# Access Compliance Report

## Public Rights-of-Way

Intersection ID: 30004	Main Street: DAY_LILLY_LN	Cross Street: MANDY_PLACE_CT	Location: SE
ADA ID: 23179B095429	Ramp Type: PerpDiag	Initial Pass/Fail: Fail	Overall Compliance: No
Severity Score: 8.75			
Codes/Mitigation Info/Possible Solution		Field Measurements/Component Compliance

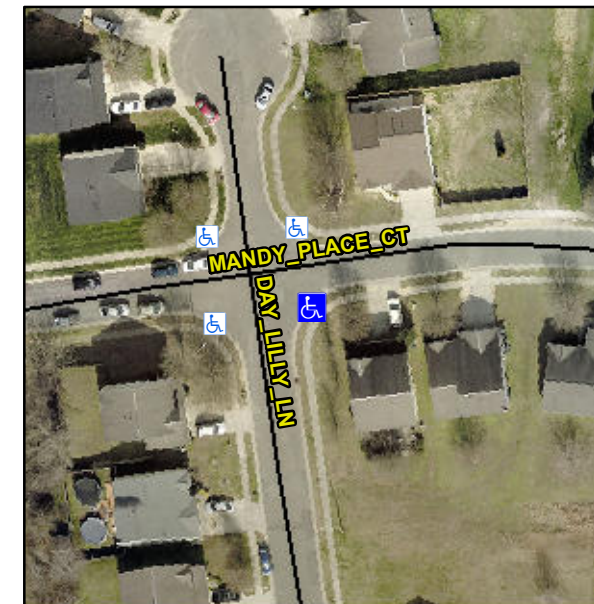
**Not Found, R304.5.1**

Compliance	Description	Data	Compliance	Description	Data
N/A	Ramp Length (in)	48.0	Yes	Ramp Slope (%)	8.3
No	Ramp Width (in)	44.0	Yes	Ramp XSlope (%)	1.3
N/A	Flare Type LT	N/A	N/A	Flare Type RT	N/A
N/A	Flare Slope LT (%)	N/A	N/A	Flare Slope RT (%)	N/A
N/A	Flare Traversable LT?	N/A	N/A	Flare Traversable RT?	N/A
N/A	Landing Length (in)	N/A	N/A	DWS Provided?	N/A
N/A	Landing Width (in)	N/A	N/A	DWS Contrast?	N/A
N/A	Landing Slope (%)	N/A	N/A	DWS Length (in)	N/A
N/A	Landing X Slope (%)	N/A	N/A	DWS Full Width?	N/A
N/A	Landing Curb? (Y/N)	N/A	N/A	DWS Offset (in)	N/A
N/A	Shared Landing?	N/A			
N/A	Gutter Ponding?	N/A	N/A	Gutter Slope (%)	N/A
N/A	Gutter Lip Ht (in)	N/A	N/A	Gutter X Slope (%)	N/A
N/A	Painted X Walk1?	No	N/A	Painted X Walk2?	No
	X Walk 1 Direction	To N		X Walk 2 Direction	To W
N/A	X Walk 1 Width (in)	N/A	N/A	X Walk 2 Width (in)	N/A
	X Walk 1 Slope (%)	2.6		X Walk 2 Slope (%)	3.5
	X Walk 1 X Slope (%)	2.0		X Walk 2 X Slope (%)	4.1

**Remove & Replace Curb Ramp With Two New Directional Ramps or Equivalent.**
